Docket Item # 17  
DEVELOPMENT SPECIAL USE PERMIT #2003-0018  
CAMERON STATION PHASE VI

Planning Commission Meeting  
November 6, 2003

**ISSUE:** Consideration of a request for a development special use permit, with site plan, for construction of townhouses.

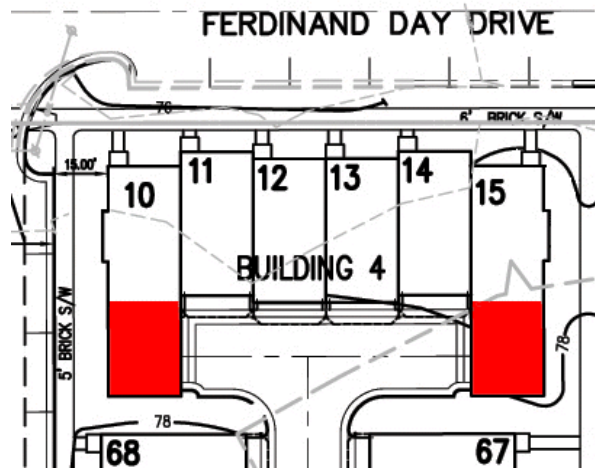
The design, orientation, and scale of the proposed townhouses are consistent with the intent of the CDD Concept Plan and are compatible with the existing development pattern of Cameron Station. A concern of staff is the lack of variation in the roof types and articulation add to the perceived mass of the buildings. A recommendation of approval is to provide more varied roof types roof materials and articulation to reduce the perceived mass of the buildings.

In addition, a recommendation of approval requires additional building articulation for 10 units (lots 1-3, 32-35 and 95-97). This is consistent with the concept for Cameron Station which seeks to provide a variety of unit types, as well as variety in building height and design. This articulation will create a street front that is varied both in elevation and plan that will contribute to a more lively and less monolithic appearance from the streets. These varied and random setbacks create building articulation that creates variety and richness for the street while still maintaining an urban “streetwall.” In addition, a recommendation of approval is that the units adjacent to the linear park be painted brick or significantly varied brick colors to provide additional variation for these units.

*Site Plan Connections - Street Grid (Red), Sidewalks (Yellow) and Pedestrian Connections (Orange)*

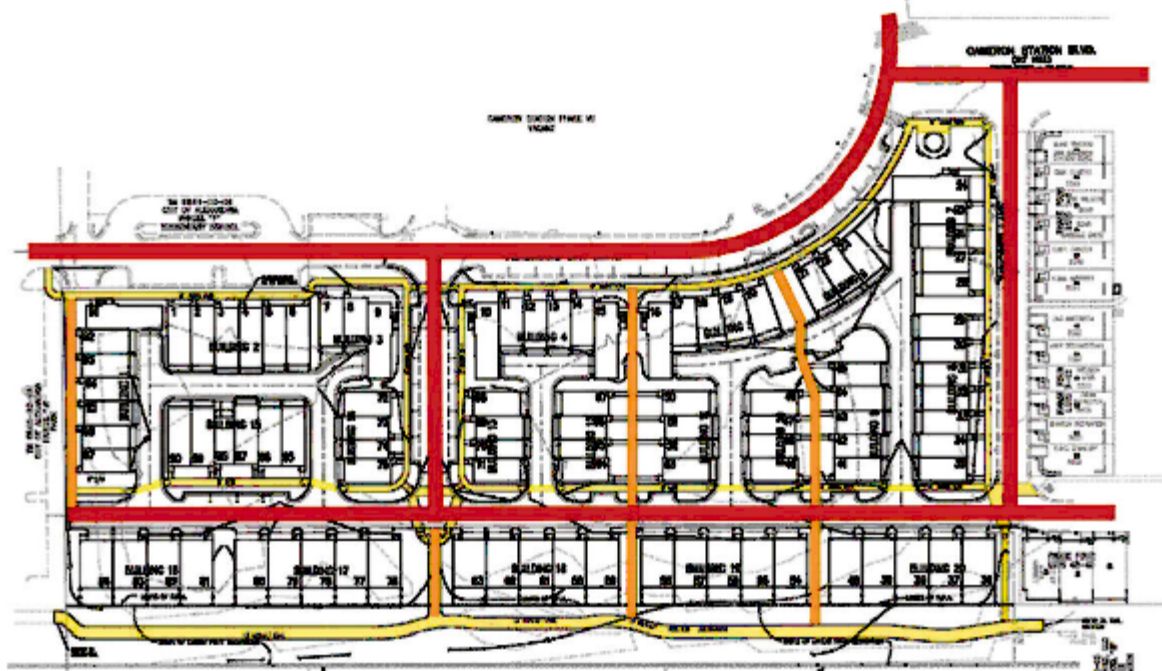
A primary concern with the previous proposal for the site was the large, uninterrupted buildings and the fact that the proposed development did not continue the existing modified street grid of Cameron Station. Therefore, from the initial concept meeting, staff has emphasized the importance of continuing the street grid and maintaining internal pedestrian connections to the linear park.

Through the concept review process and at the request of staff, the applicant has revised the plan to provide a street grid, internal open space areas, and pedestrian connections for the adjacent linear park. In addition to providing physical connections to the linear park and throughout Phase VI, these connections also provide visual breaks for the proposal.
